From:Lindsey OzboltSent:Friday, January 27, 2017 4:18 PMTo:'Nate Thompson'Subject:RE: ELST 60% Plan Homeowner Feedback - 2325 East Lake Sammamish PL SE - Signed
Letter

Thank you for contacting the City of Sammamish regarding the current Shoreline Substantial Development Permit Application for East Lake Sammamish Trail Segment 2B (SSDP2016-00415).

Subject: East Lake Sammamish Trail Segment 2B

View of Backyard area proposed to be developed into Rest Stop, note un-tagged Old-Growth Douglas Fir trees:

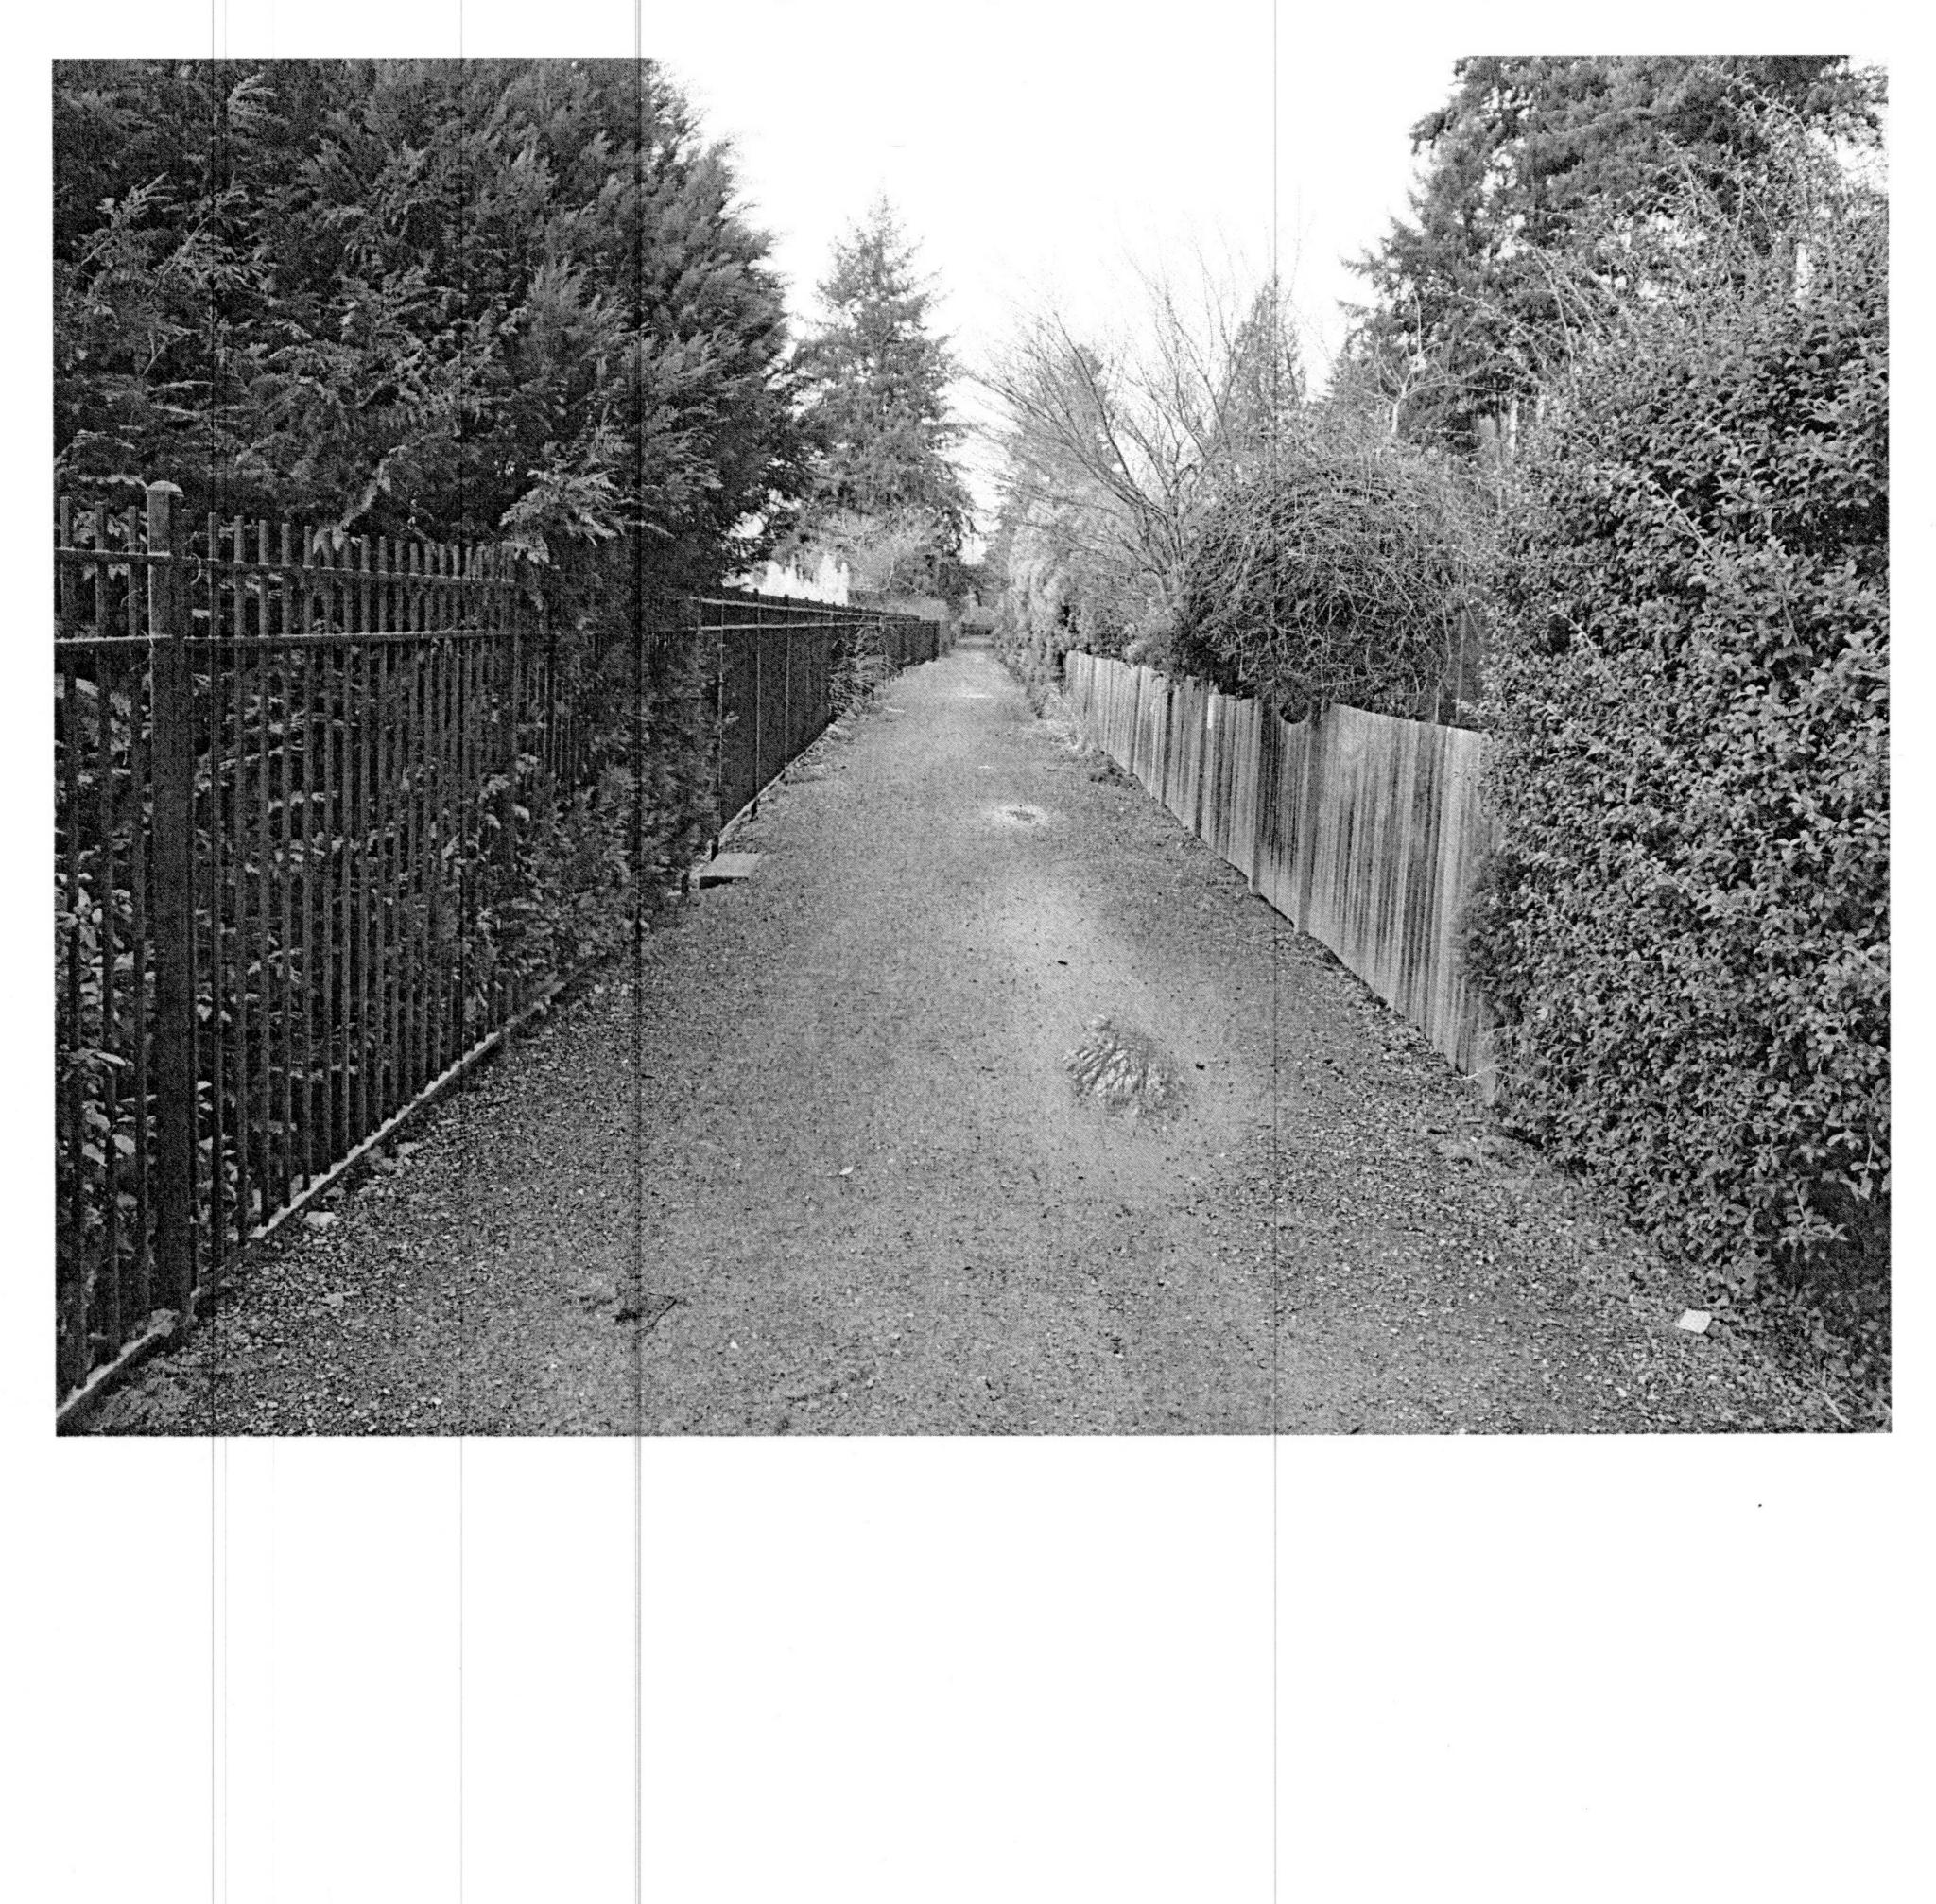
8759 as shown on page TP6 of the Tree Preservation Plan. However, there are a significant number of additional old-growth Douglas Fir trees in the immediate vicinity – as close to the proposed trail as the tagged trees in some cases. Why haven't all of these trees – of similar location, size, species and importance to the local neighborhood – been tagged for preservation? We request that every one of these old-growth Douglas Fir trees adjacent to the trail to be tagged and added to the Tree Preservation Plan, and that they are marked to SAVE as noted with the three trees currently listed.

We are highly concerned about the decision to include a rest stop (note 12) in our yard. We have a number of questions, and for several reasons we urge you to consider removing it or moving its location.

View of Trail with wood and metal fencing installed by homeowner:

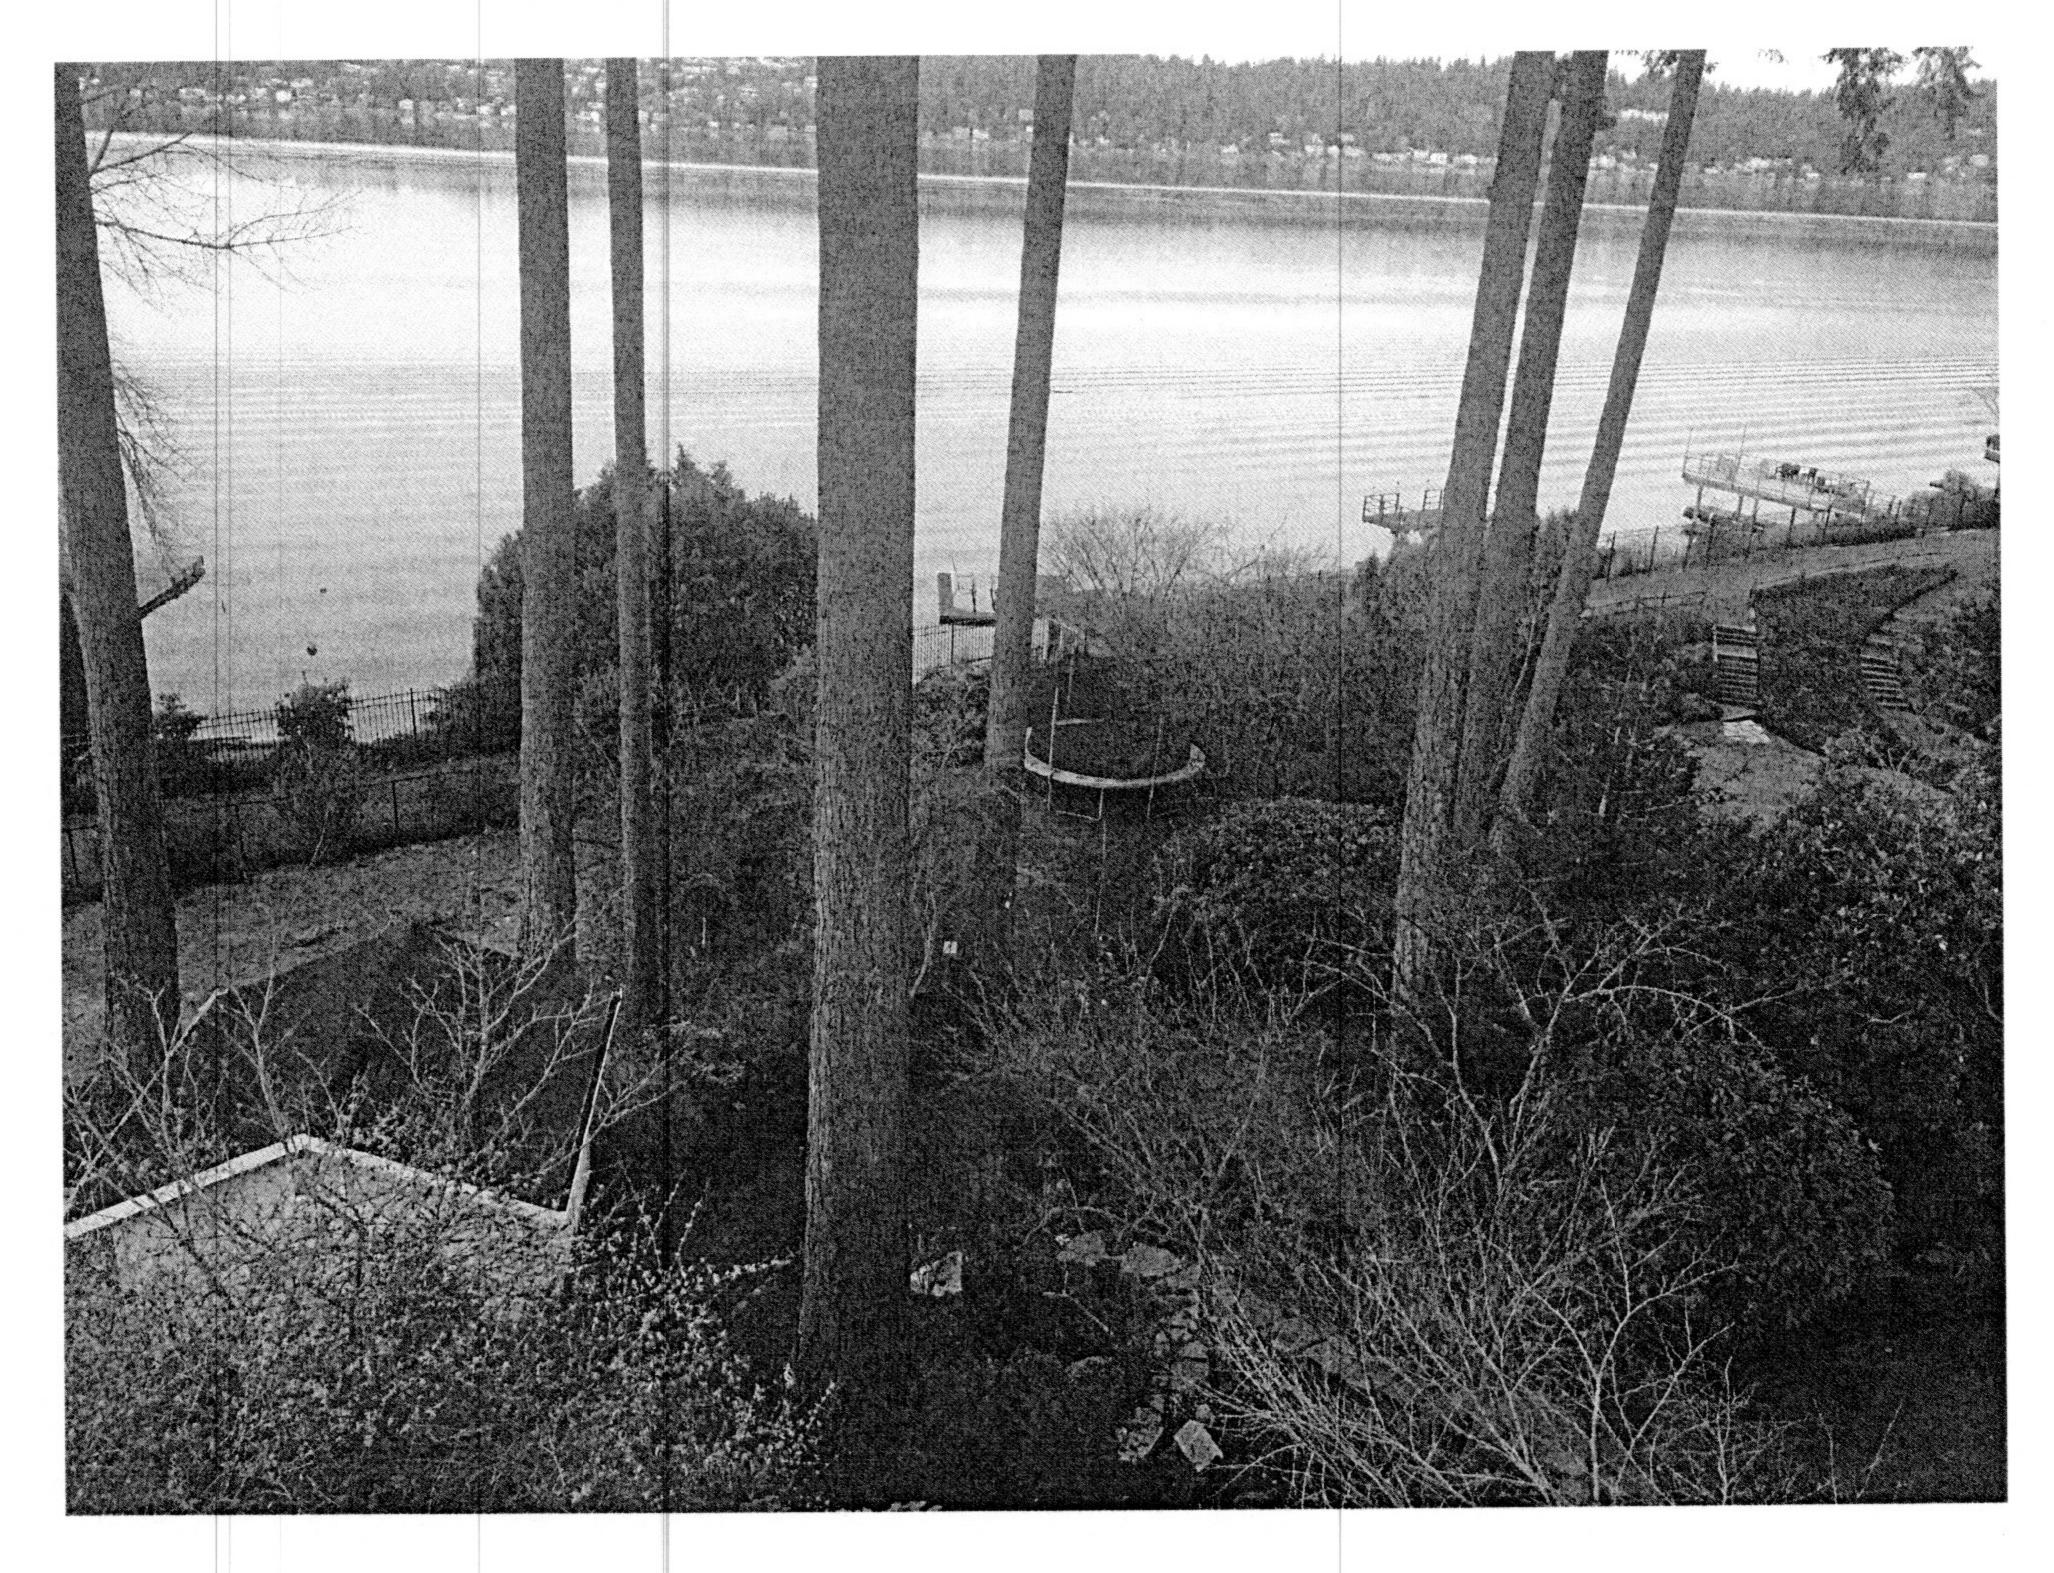
- 1) Currently the plans do not show fencing being replaced along either side of the trail. This is concerning for several reasons.
 - a. First, on the water side, there is a steep drop to the lake and a significant amount of that is comprised of large boulders and rocks. A trail user veering off the trail onto this slope – especially at any significant speed – will be at risk for grave physical harm. What is the rationale in removing the fencing that is there today, and not replacing it? We request that this is addressed by the current fencing, which was installed at the expense of the community homeowners, to remain in place during and after construction, or,

- b. replacing the fencing on the water side of the trail with fencing comparable to what is in place today including a gate for access.
 - c. Second, there is no fencing replaced on the uphill side of the trail. We have both small children and pets the current fence keeps them inside the yard safely. It also keeps trail users on the trail and not in our yard. Providing unfettered access onto the trail from our yard, and into our yard from the trail is not safe for our family, or trail users. We request that this is addressed by replacing the fencing on the uphill side of the trail,

Photo #2 - View Looking South

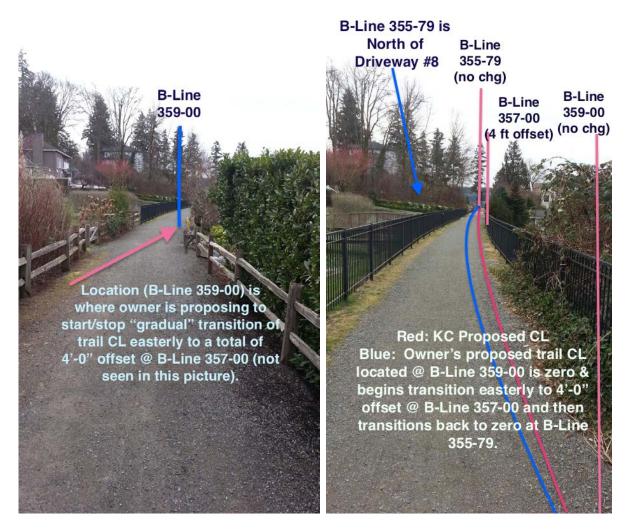
The following is our proposal to shift the centerline as currently proposed in the 60% Design plans to the <u>existing centerline of the current Interim</u> <u>trail</u>.

IMPORTANT: Our proposal is to just shift the KC proposed centerline BACK to the center of the existing Interim Trail.

- b. Justification for Requesting Trail Re-alignment
 - i. Current plan by KC/Parametrix is to remove at least two mature (25+ year) Alpine fir trees and assume three other 25+ year trees that are unmarked by Parametrix but within the CG construction area.
 Shifting the trail provides a very good possibility that all of these five 25+ year mature trees will be saved.
 - ii. If it's possible to save these trees, they provide a visual buffer from the trail to our beach property, patio, dock and swimming area. If not, what is KC/Parametrix doing to replace the privacy screen these trees provide from trail users onto our beach property?
